PIMA COUNTY

ADDENDUM NO. 1

SOLICITATION NO. 220377 PANTANO WASH BANK PROTECTION AND RIVER PARK PHASE III: TANQUE VERDE ROAD TO FORT LOWELL PARK (5PWFLT)

HABITAT RUBBLE PILE (1 of 2)

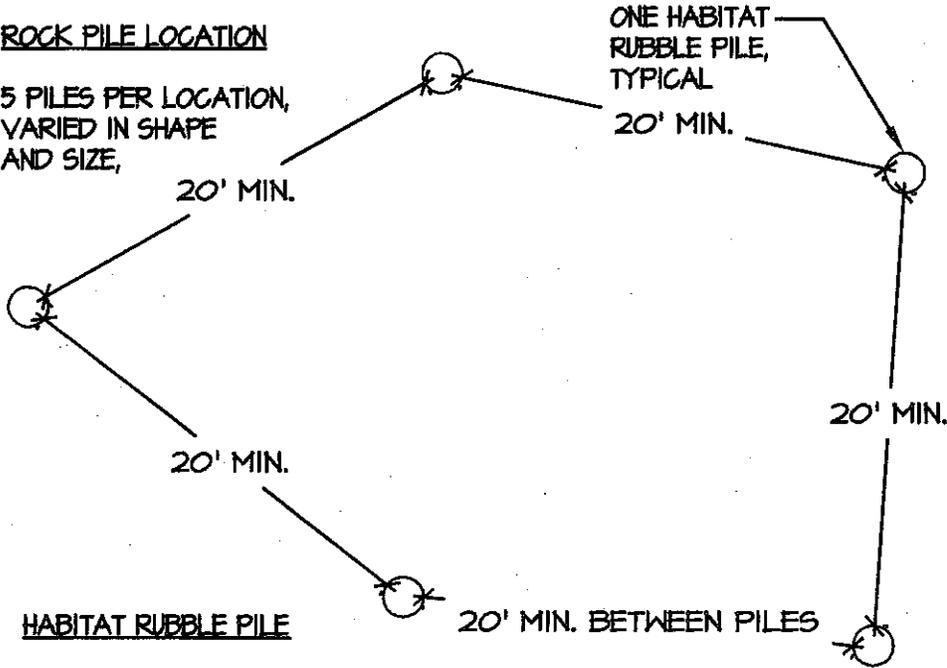
REVISED DETAIL 7, SHEET L20 (12 OF 140)

5 PILES PER LOCATION, VARIOUS IN SHAPE AND SIZE,

EACH PILE TO BE BETWEEN 1 AND 2 CUBIC YARDS IN VOLUME.

ROCKS AND CONCRETE RUBBLE, 6" MIN-18" MAX IN DIAMETER

HABITAT RUBBLE PILE (2 of 2)

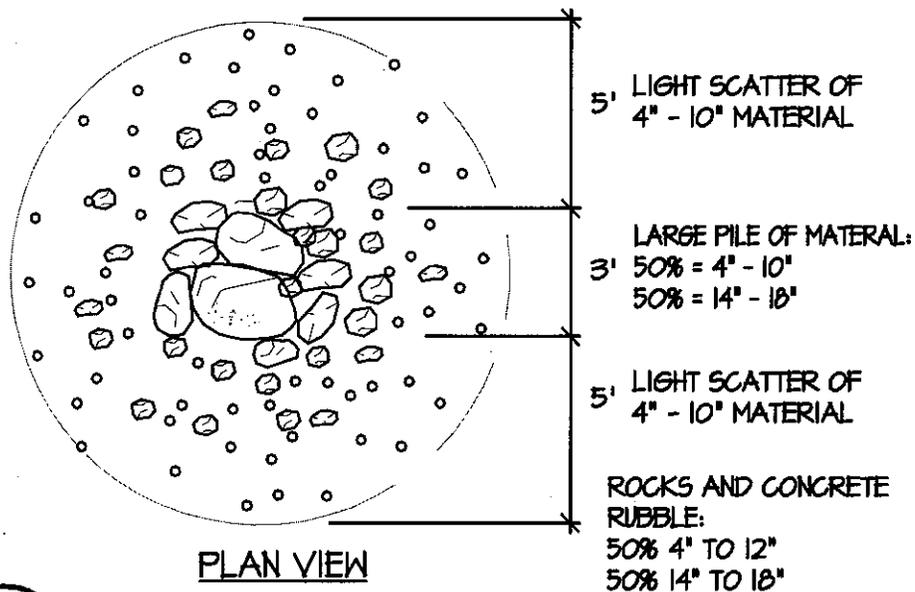
REVISED DETAIL 7, SHEET L20 (12 OF 140)

1. FINAL LAYOUT OF PILES SHALL BE APPROVED BY THE OWNER'S REPRESENTATIVE, SEE SPECIAL PROVISIONS.
2. CONCRETE RUBBLE ONLY ALLOWED IN LOW VISIBILITY AREAS WITH ENGINEER'S APPROVAL.
3. ROCK COLOR SHALL BE "APACHE BROWN" OR APPROVED EQUAL.
4. EACH PILE TO BE BETWEEN 1 AND 2 CUBIC YARDS IN VOLUME.
